Product Group:	Date Issued:		Service Bulletin No.		
Power Solutions	04/26/17		GSP20170320		
<b>Bulletin Type</b>		Models/Series Affected:			
Mandatory		DCA125SSIU4F S/N 7511166-7511401, 7511404-7511405,			
Information Only		7511407-7511415, 7511417, 7511419, 7511424, 7511425, 7511431, 7511450, 7511453, and 7511470			
X Recommended Change

The coolant hose clamp at the thermostat housing may not be tightened to maximum factory torque specifications, creating the potential for a coolant leak or decoupling of the coolant hose.

Figure 1. T-Bolt Hose Clamp

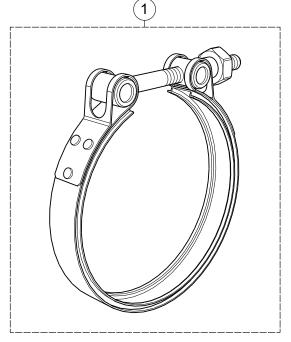
If undamaged, the existing worm clamp on the coolant hose may be reused for this procedure. However, Multiquip has enhanced future DCA125SSIU4F production by changing the thermostat housing hose clamp to a T-bolt clamp (Figure 1), improving hose clamping capability and reducing the possibility of leakage or decoupling. If the existing worm clamp is damaged, or if you simply prefer the new T-bolt clamp, it can be provided free of charge through MQ warranty reimbursement. Contact the MQ Parts Department to order.

Item No.	Part No.	Description	QTY.	Remarks
1	Y0605515304	T-Bolt Hose Clamp	1

Figure 5. Hose Stop to Hose Clamp
Measurement

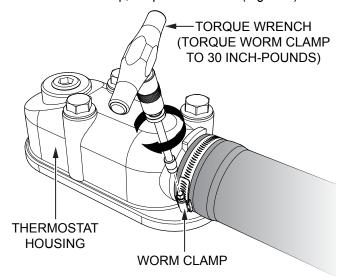
Make sure the coolant hose does not rest *on top* of the thermostat housing hose stop. The distance from the outer edge of the hose stop to the outer edge of the hose clamp must measure 1". See Figure 5.

Figure 7. Torque New T-Bolt Clamp

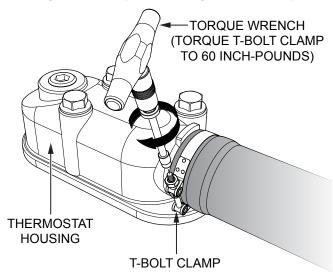
6. Tighten the coolant hose clamp to secure the hose to the thermostat housing. If reusing the existing worm clamp, torque to 30 in-lbs (Figure 6). If installing the new T-bolt clamp, torque to 60 in-lbs (Figure 7).
